ADDENDUM

ADDENDUM NO.: 2
PROJECT NAME: CPS 2015 Air-Conditioning Program – Region C Project
PROJECT NO.: 05947; 05950; 05927; 05952; 05931; 05932; 05957; 05958; 05959; 05962; 05944; 05946
CONTRACT NO.: C1570C
DATE OF ISSUE: June 12, 2015

NOTICE OF CHANGES, MODIFICATIONS, OR CLARIFICATIONS TO CONTRACT DOCUMENTS

PBC Project Name: **CPS 2015 SUMMER A/C PROGRAM**
 PBC Contract No: C1570
 PBC Project No: 05947
 FGM Project No.: 15-2016.01
 Title: **FIRST FLOOR ELECTRICAL PLAN**
 Sheet: **E1.1.0-AN**

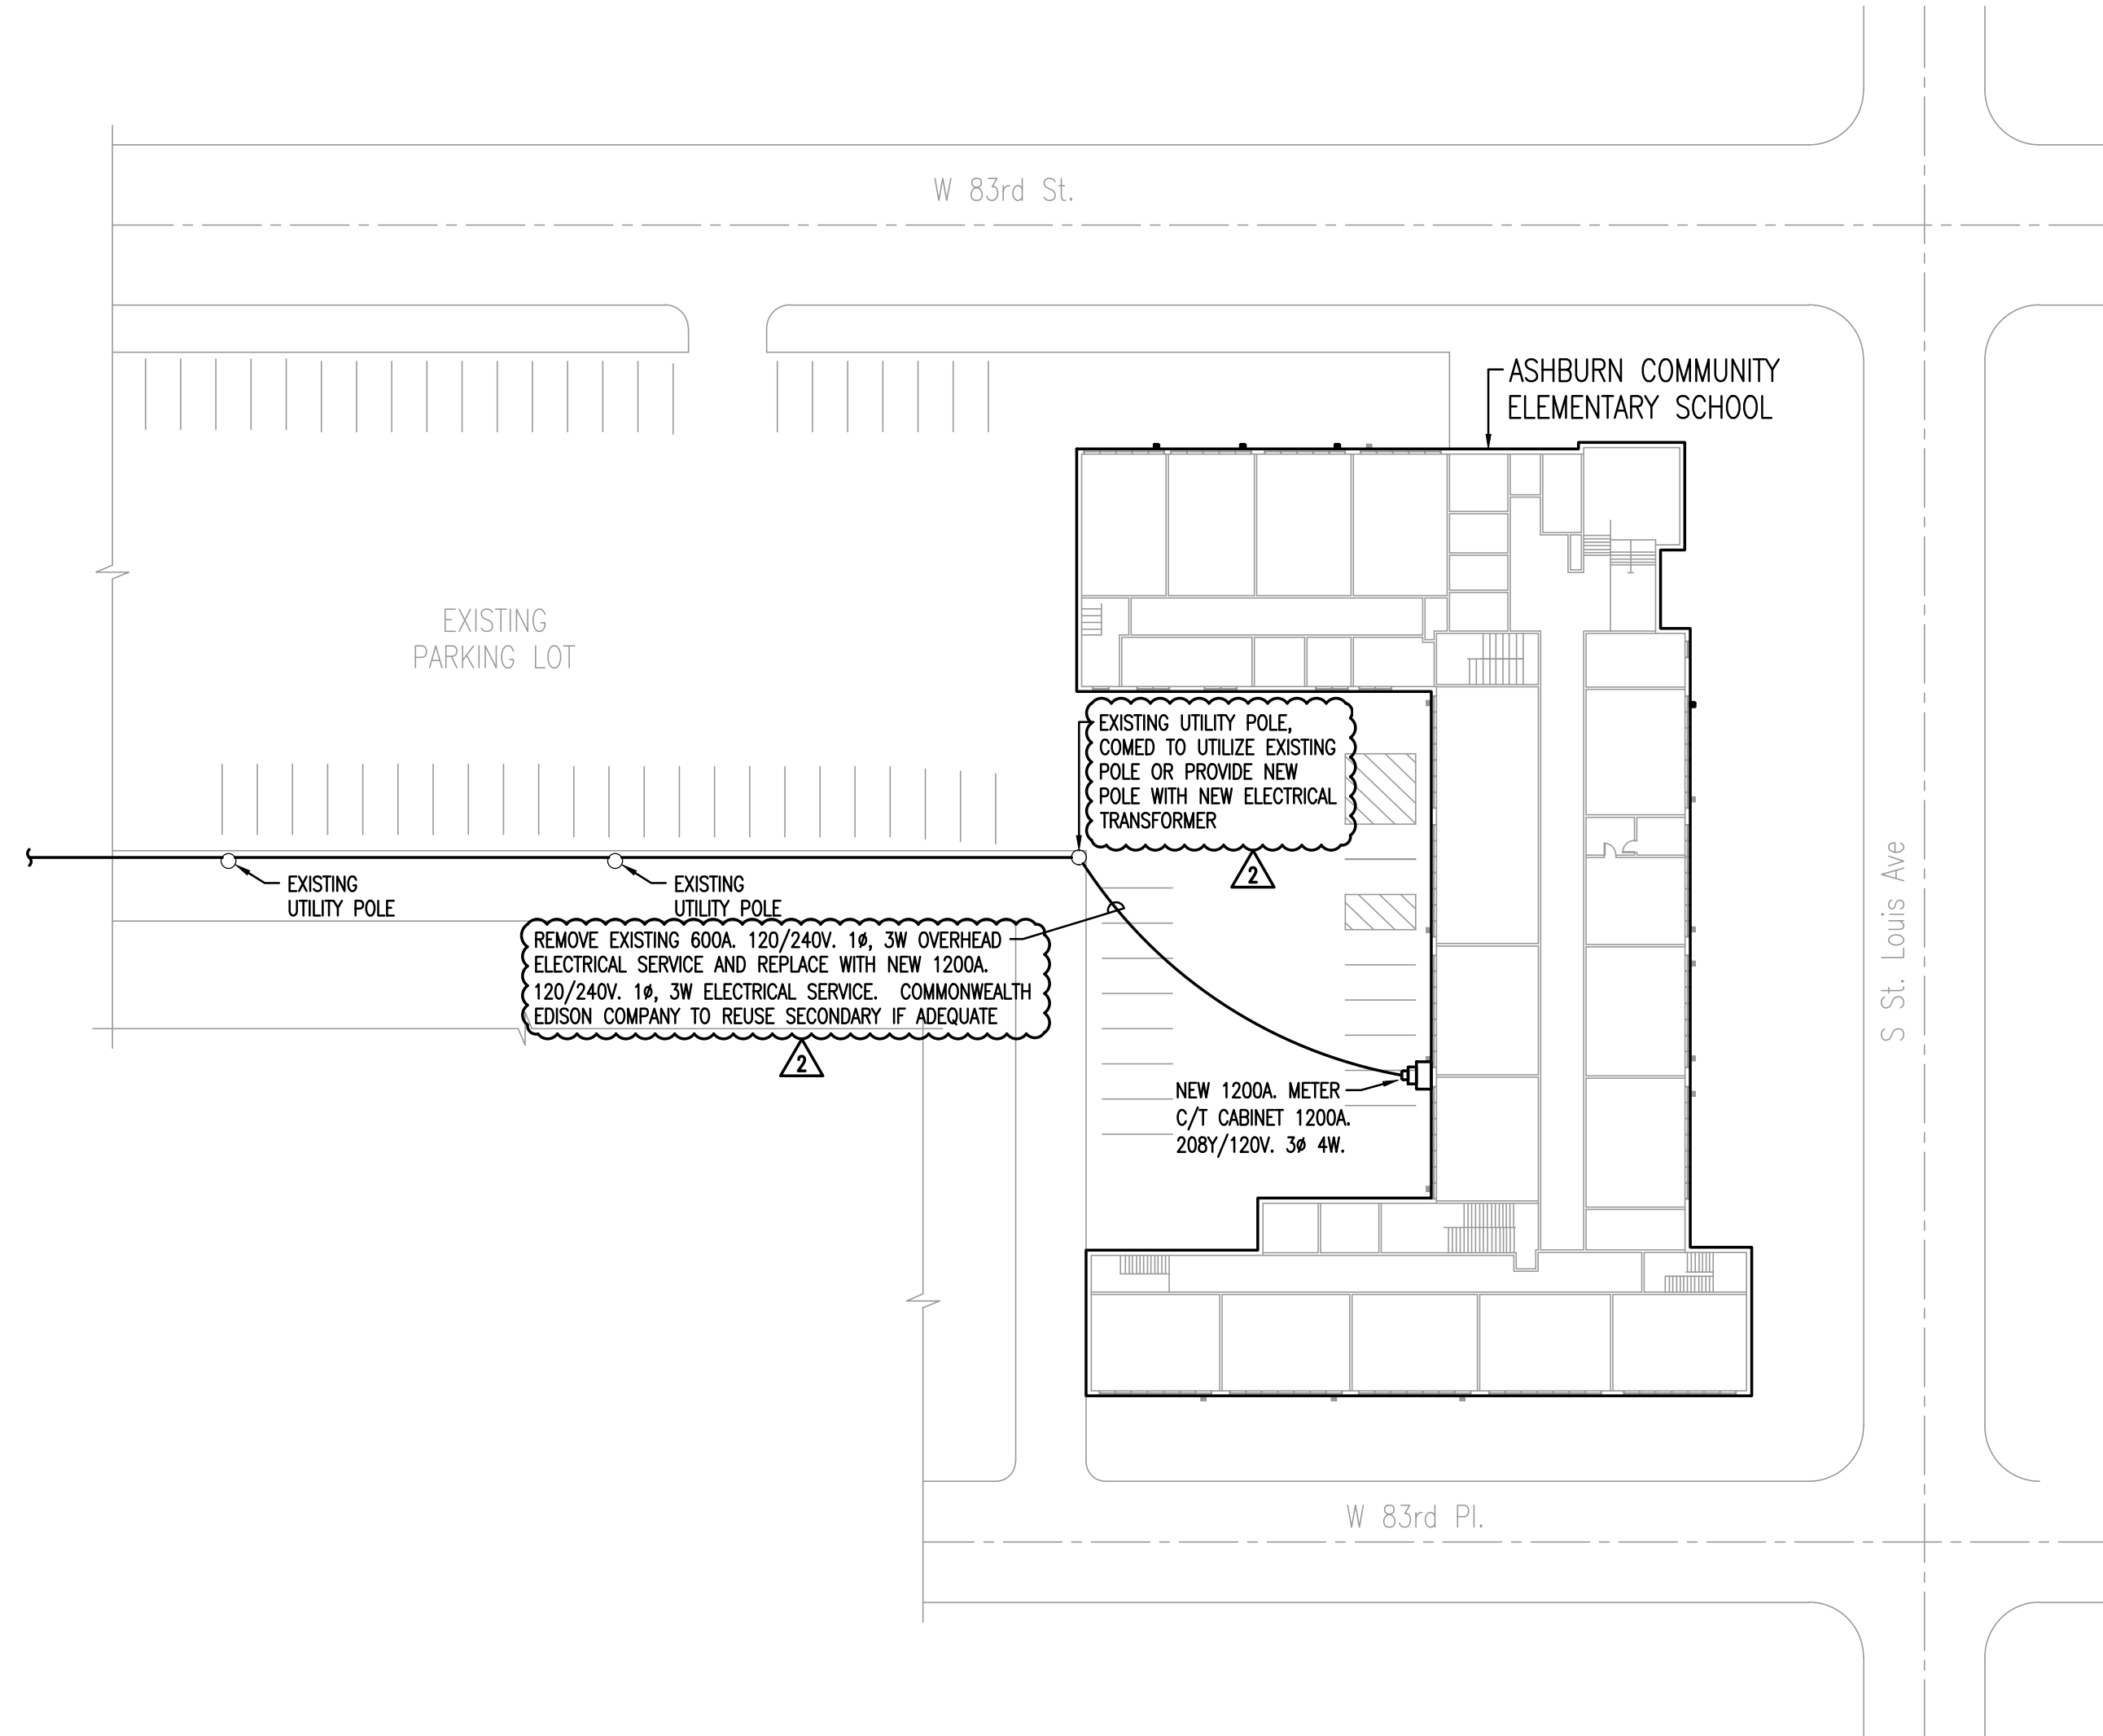
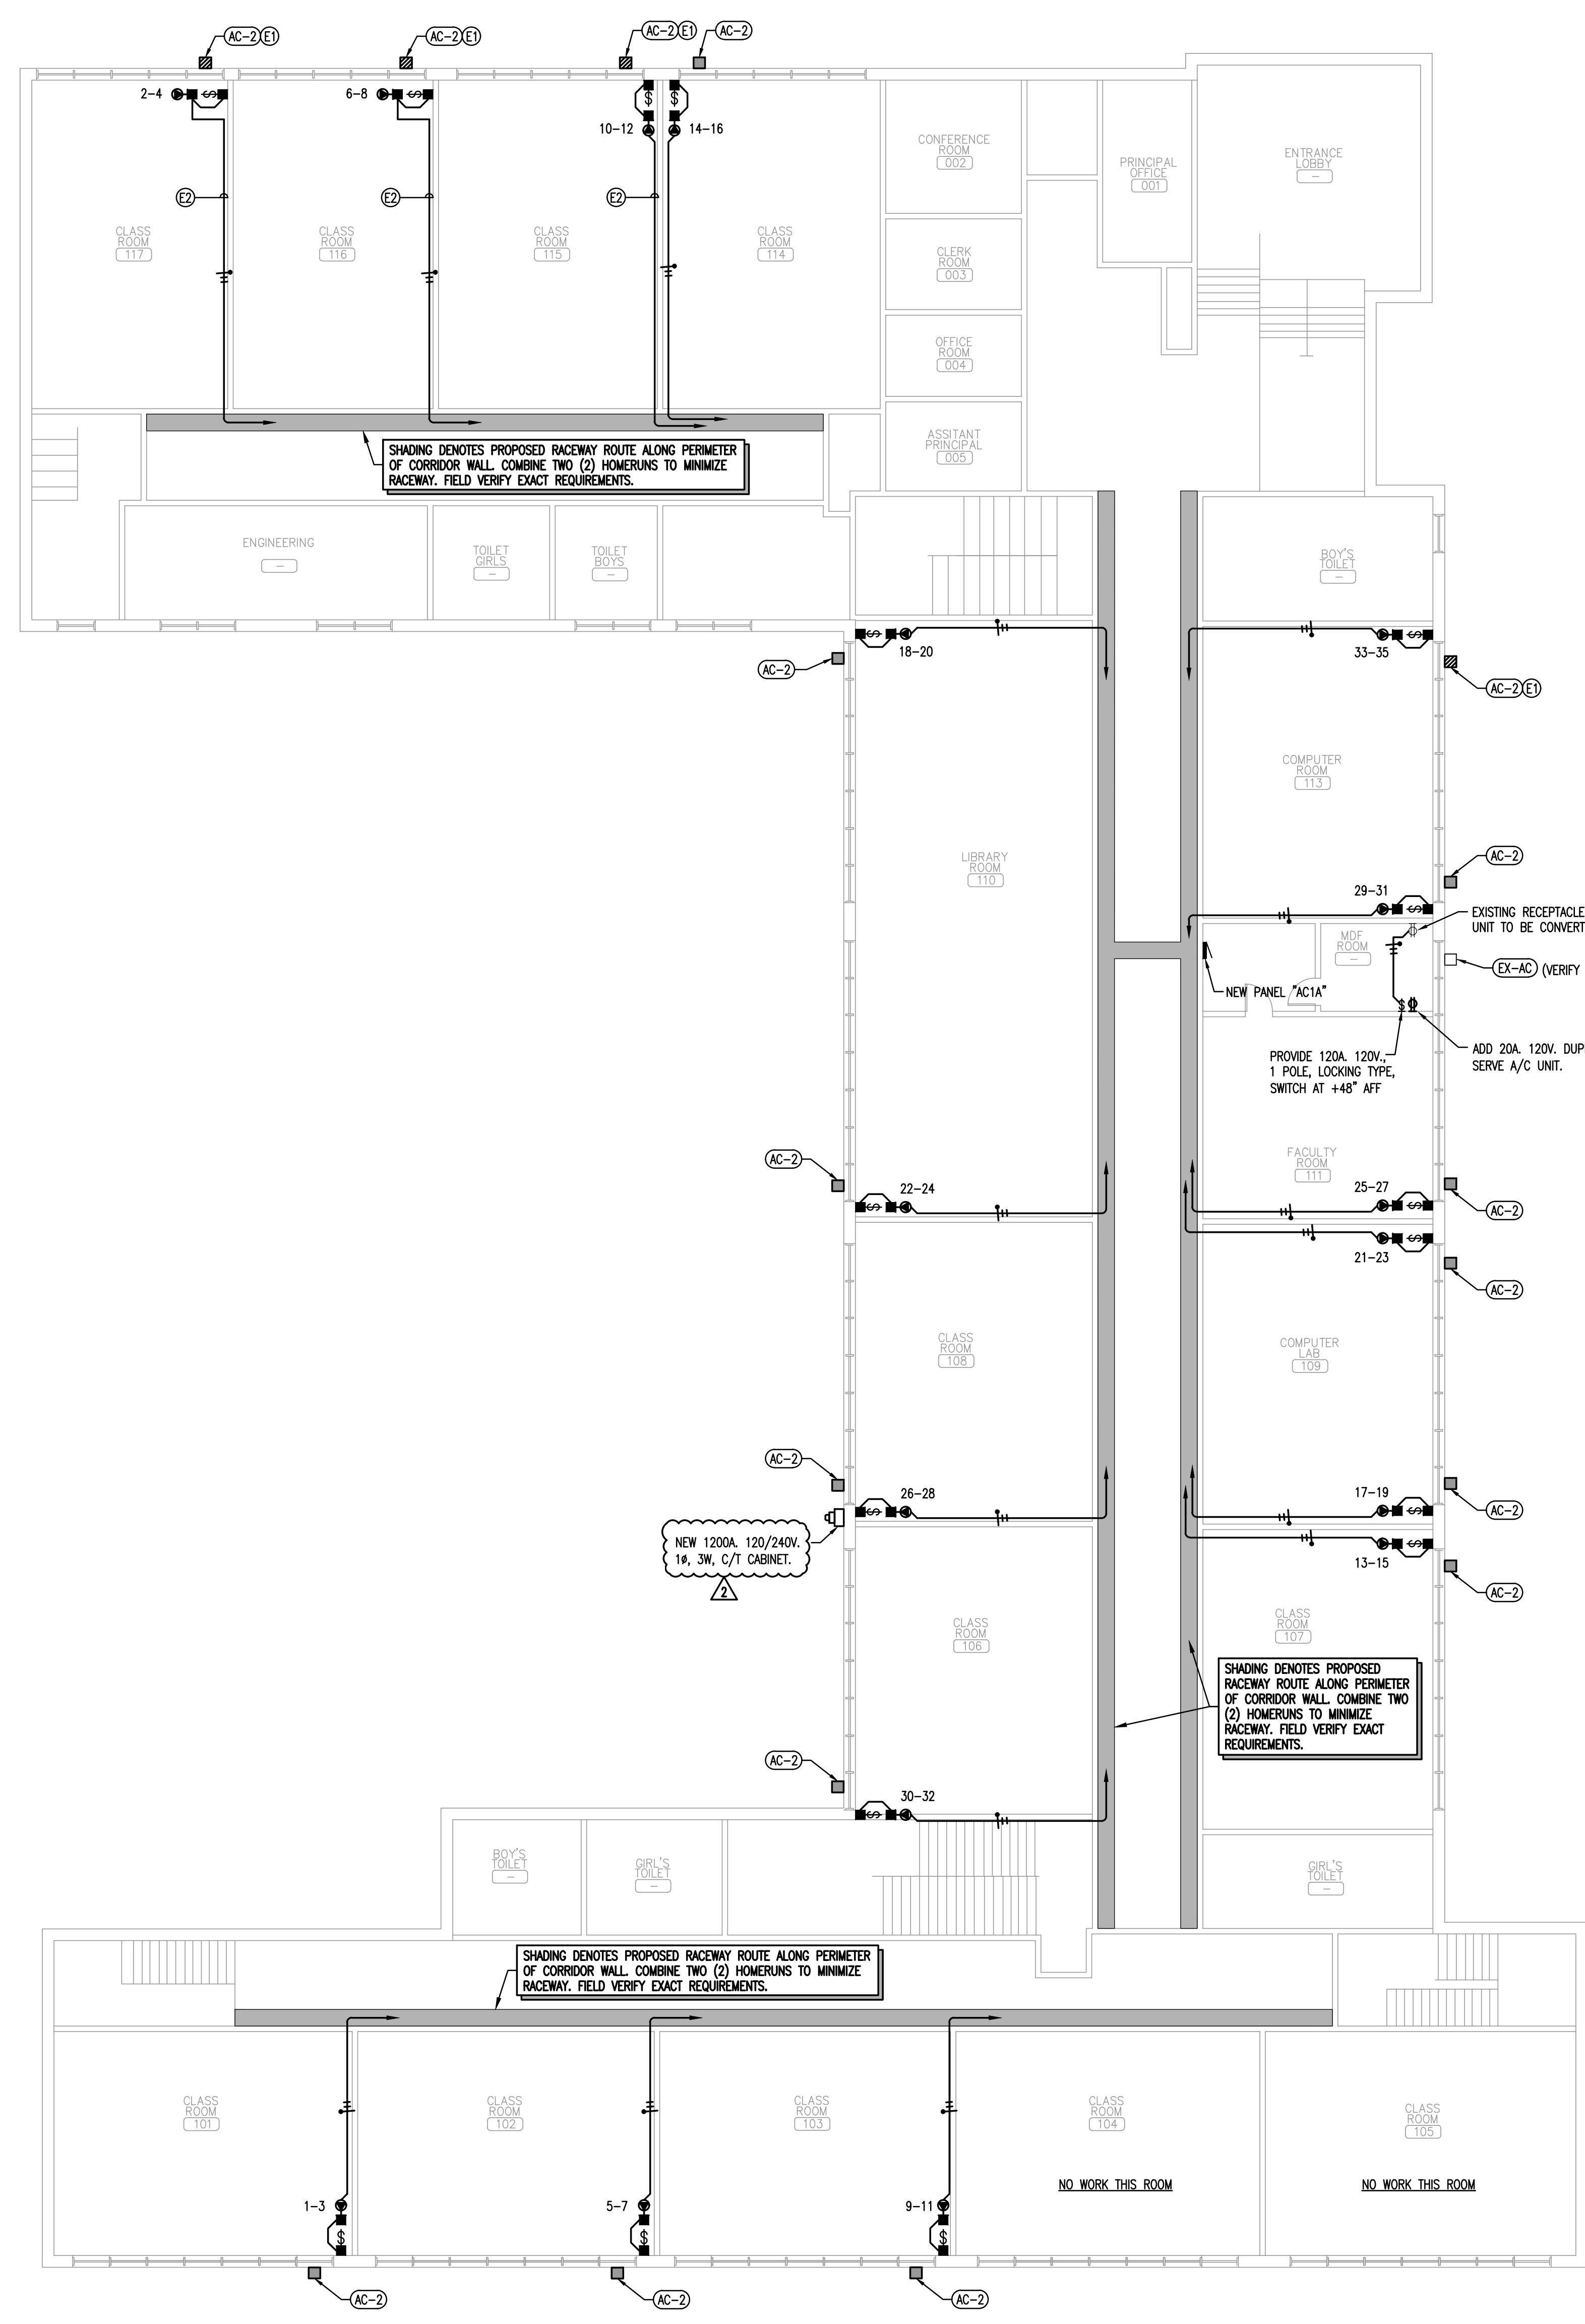
3. ASHBURN, drawing sheet E1.1.0-AN – FIRST FLOOR ELECTRICAL PLAN
 - a. FIRST FLOOR ELECTRICAL PLAN, revise per attached sheet E1.1.0-AN
 - b. ELECTRICAL SITE PLAN, revise per attached sheet E1.1.0-AN
